TECHNICAL NOTE TN-1145

TM8200 and TM9100 Control Head Component change

31 January 2006

This Technical Note details a change to the TM8200 and TM9100 Control Heads - TMAC40-0T and TMAC41-1T respectively.

Steady State Current

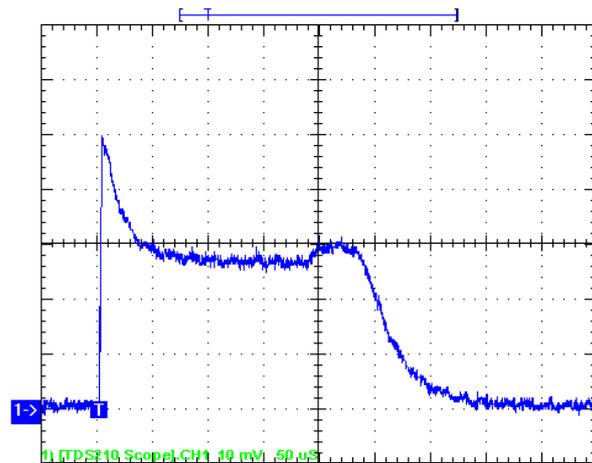
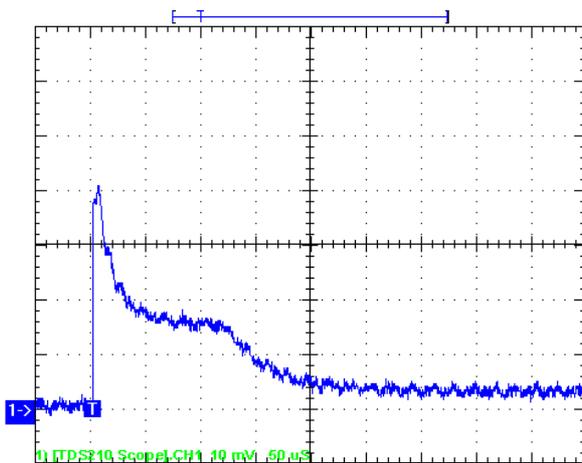
Both steady state and transient currents in R119 were monitored with both the T2000-A19 and TPA-SV-006. This testing revealed that R119 is being exposed to a current pulse, when a programming lead is plugged-in, to a powered-up radio.

The measured current through R119 during a radio read/write cycle.

This level is well within the limits of R119.

It can be seen when using the TPA-SV-006 that both the 10 μ S or 230 μ S areas of the pulse, and the 10 μ S pulse of the T2000-A19, are above the allowable limit for pulse power in the fusible type resistor but below the allowable limit for a standard type resistor. These pulses are caused by the capacitor on the supply line of the programming lead RS232 circuitry.

The T2000-A19 capacitor is 1 μ F and the TPA-SV-006 has a 2.2 μ F.

Change R119:

From: IPN 036-12100-22 - RES 1206 10R 5% Fusible

To: IPN 036-02100-02 - RES 1206 10R 5% 0.25W
